ZONING CHANGE REVIEW SHEET

CASE: C814-2017-0001 – 425 W. Riverside PUD

ADDRESS: 425 W. Riverside Drive

ZONING FROM: CS-1-V-NP **TO:** PUD-NP

EXHIBIT - TREE PLANTING DETAILS

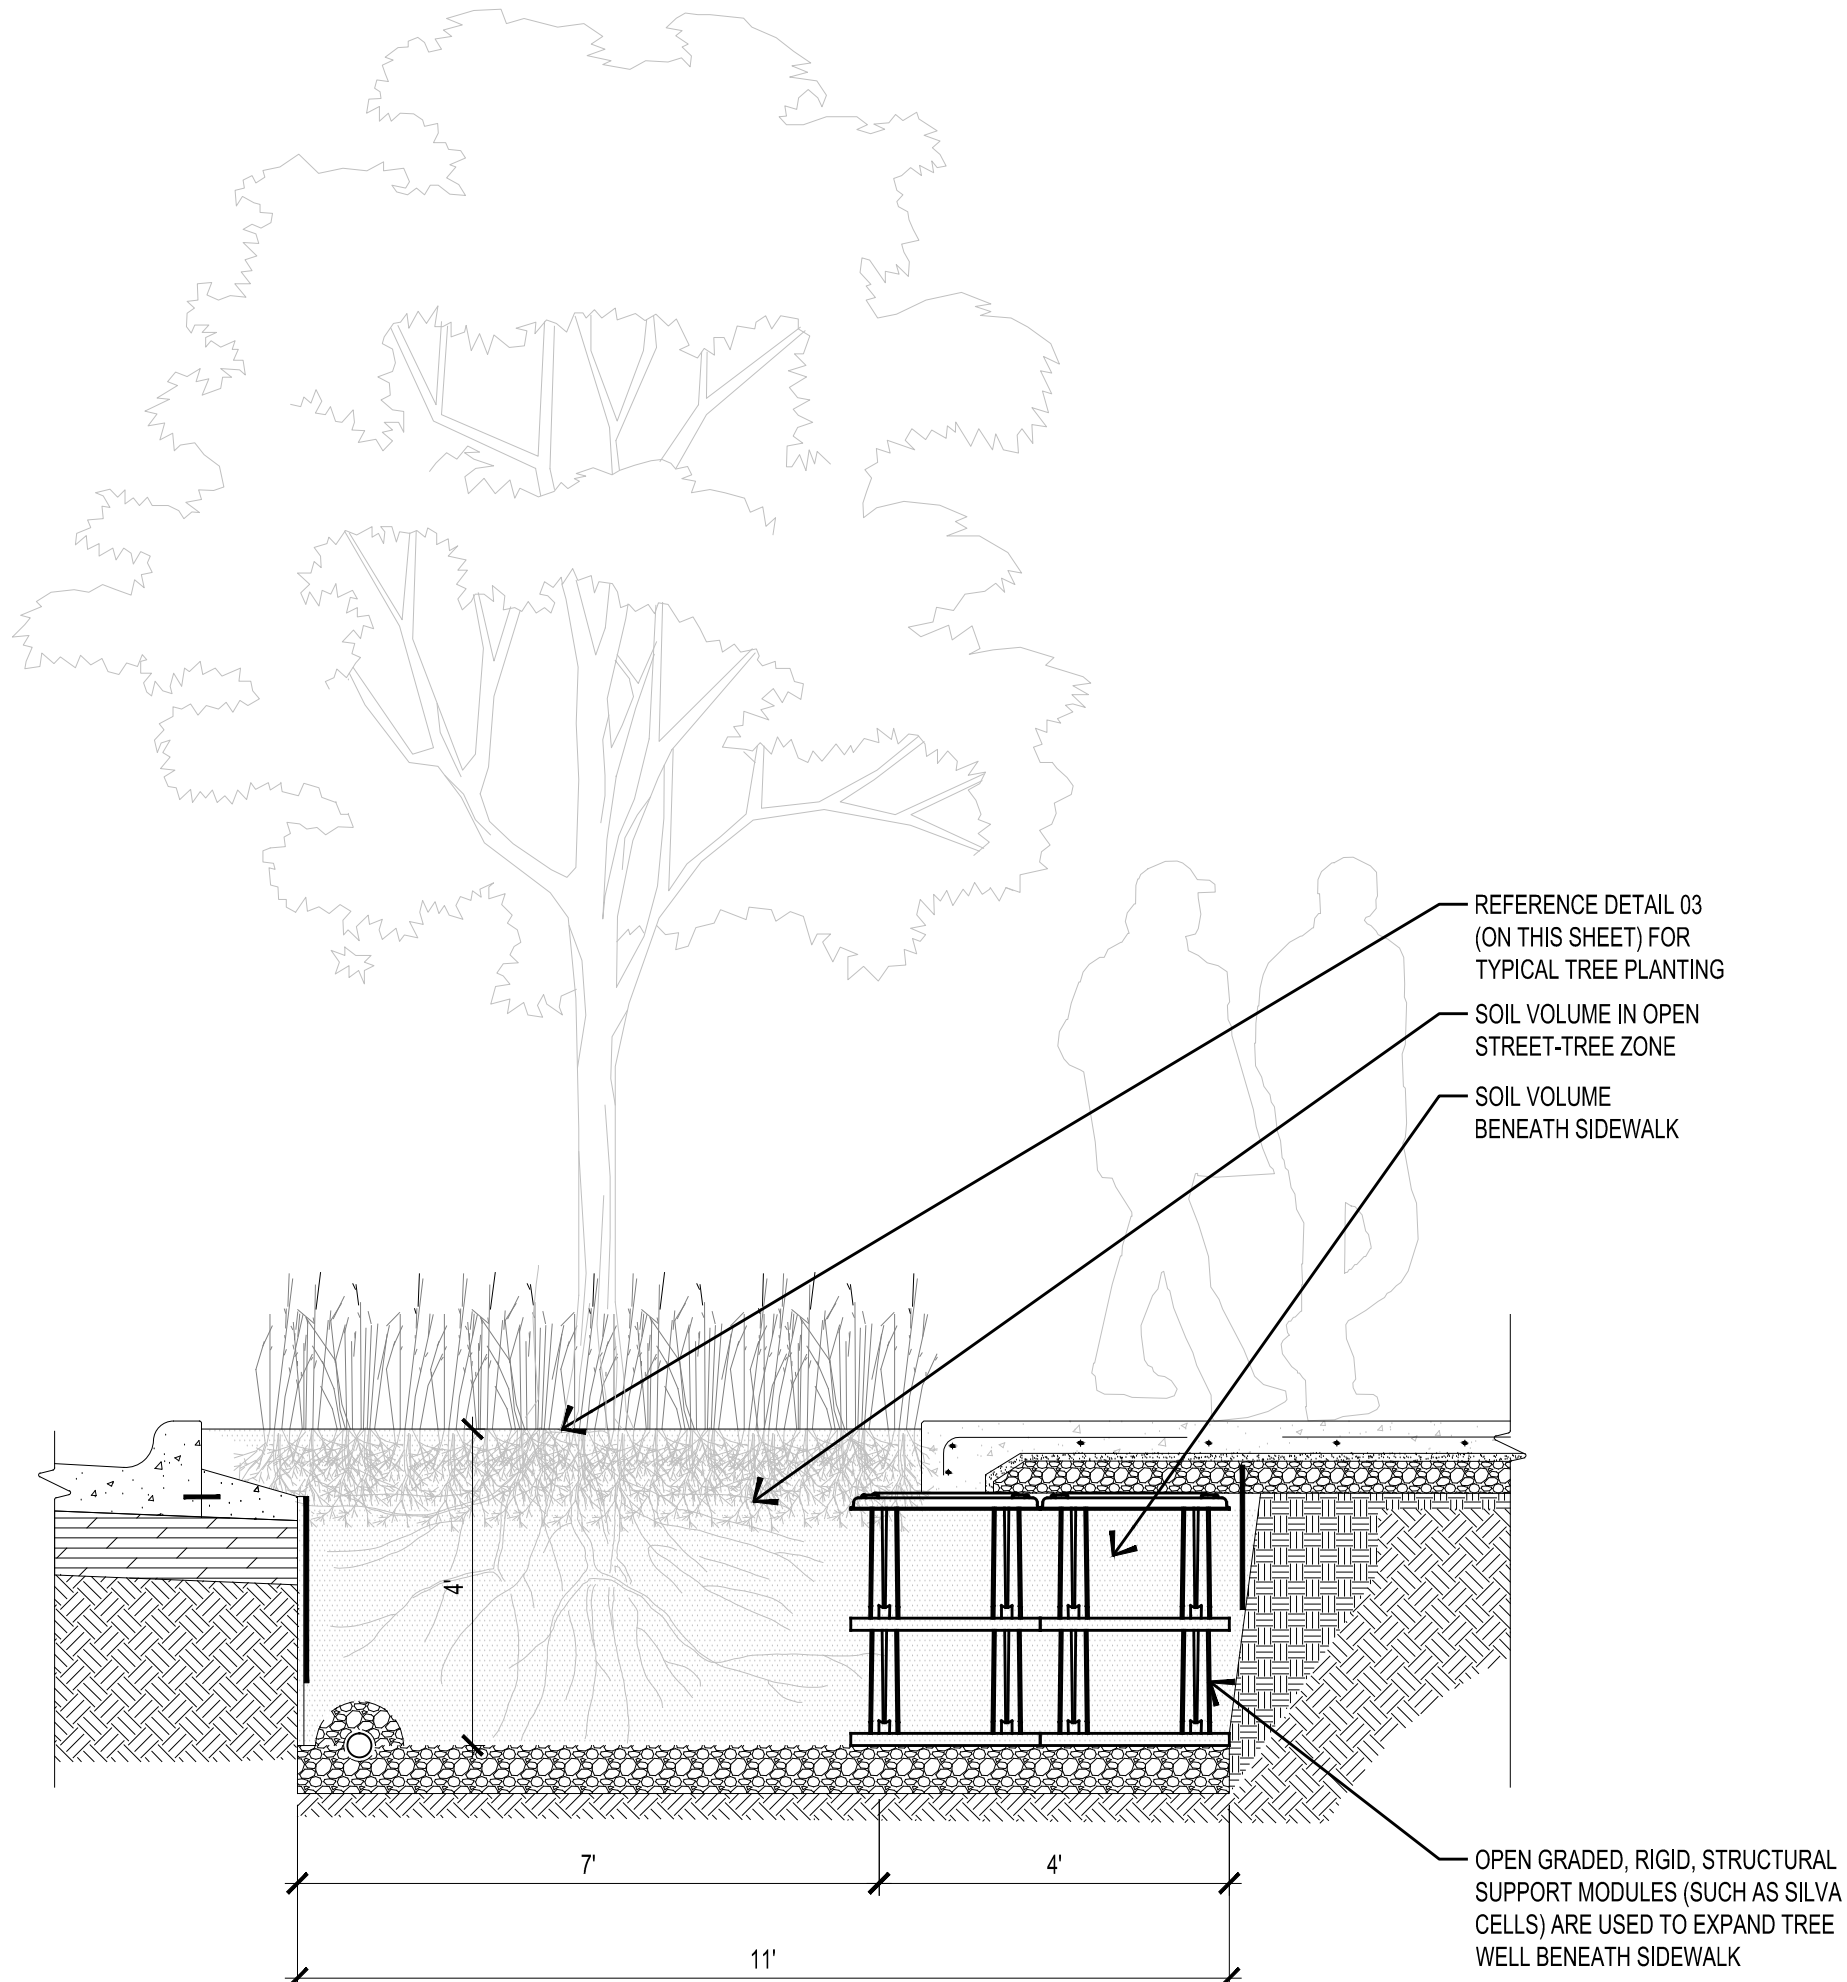
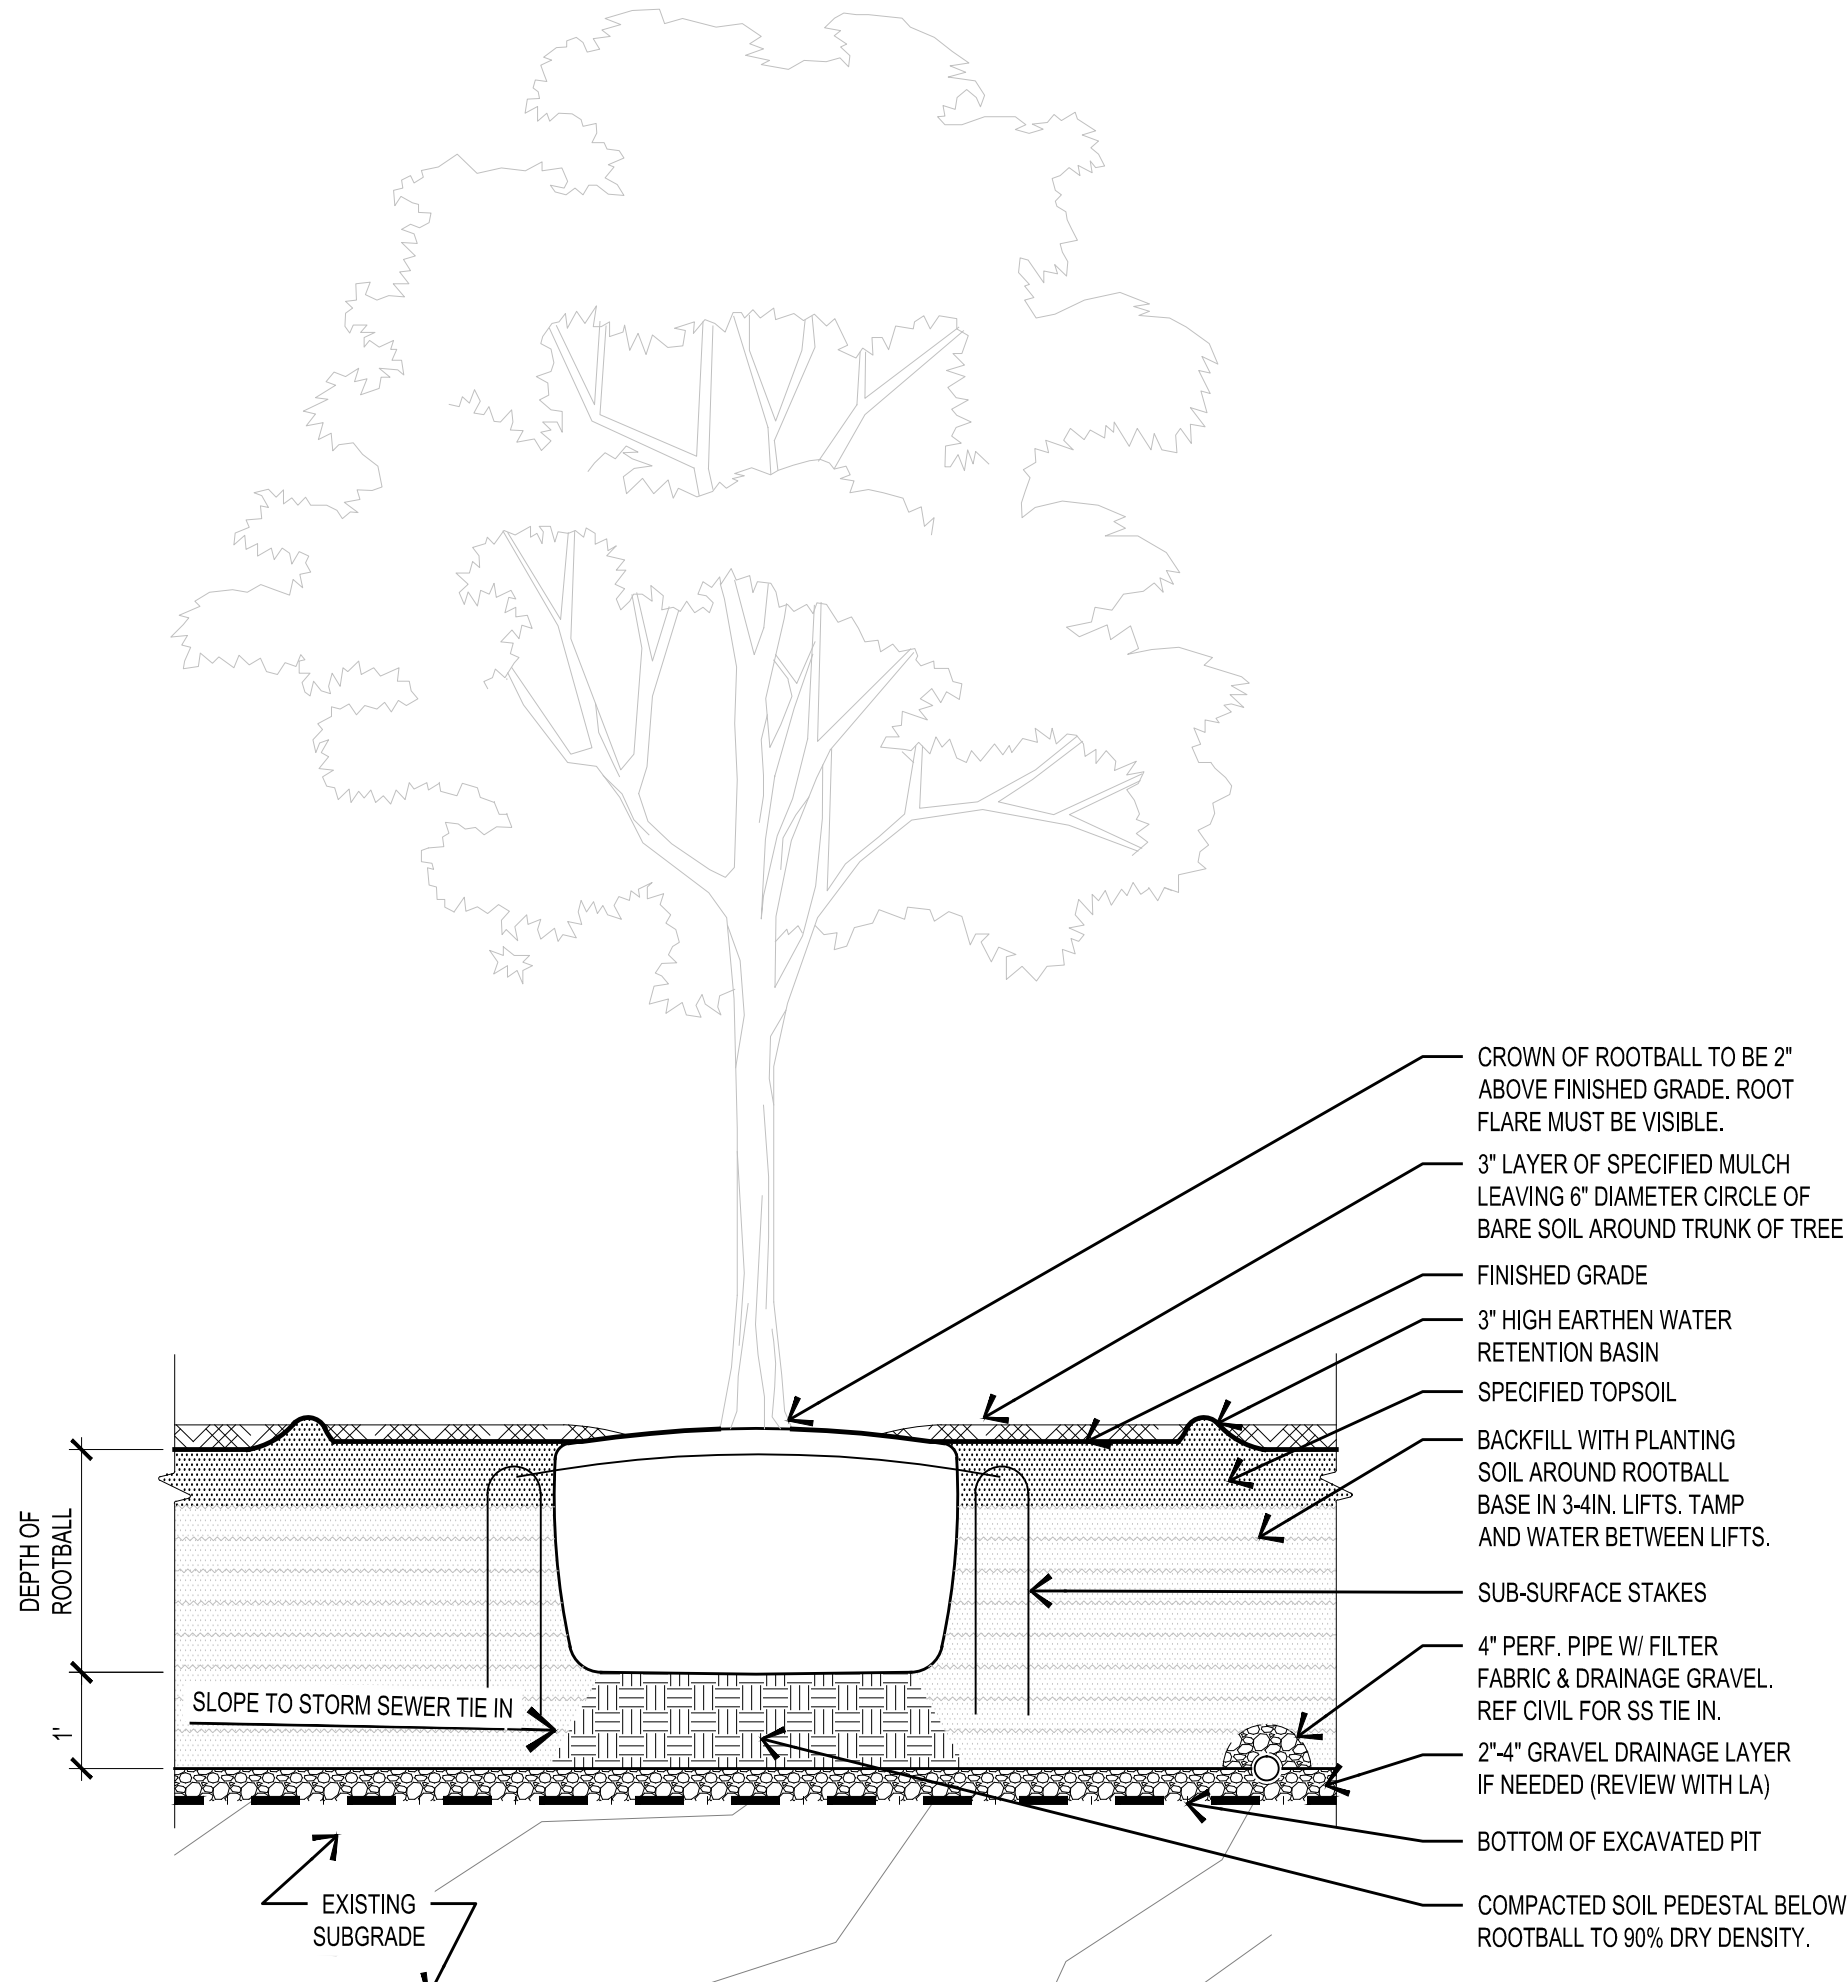
UPDATE 1: Please show how at the proposed spacing between street trees the PUD can achieve 1,500 Cu.Ft per tree. See HT 1 response. The proposed rain garden areas would not seem to be able to meet this area requirement if they were walled confined spaces. Please clarify if the planting zone is truly 8 feet or if it will really be 7.5 feet or less to account for the curb or any type of moisture barrier between the zone and back of curb. Comment pending.

UPDATE 3: Thank you for the additional information and calculations. While the PUD proposed planting of a larger diameter street tree could be considered for some environmental superiority, it would normally be a proposal to plant more trees than what would be required that would carry more weight. The PUD proposes a starting overall total frontage a bit less than the current code scenario. It also proposes an additional loss of frontage to accommodate greater options for alternative transportation with two new bus stops. These additional losses in total only allow the PUD scenario to plant one additional tree than the current code option. In this case, it will be the guarantee to plant a shade tree of higher quality that will carry some environmental superiority. To this point, because a multiplier has been used in both calculations to estimate loss due to utility conflicts and not on the ground verification staff is still not able to support the overall tree planting estimates.

Please also revise your soil commitments and notes to be consistent with the last update. These should include the larger 1540 CY soil volume required in locations other than ones with utility conflicts. In those cases where it is proven utility conflict then 1000 CY minimum is accepted with the use of soil cells. Comment pending.
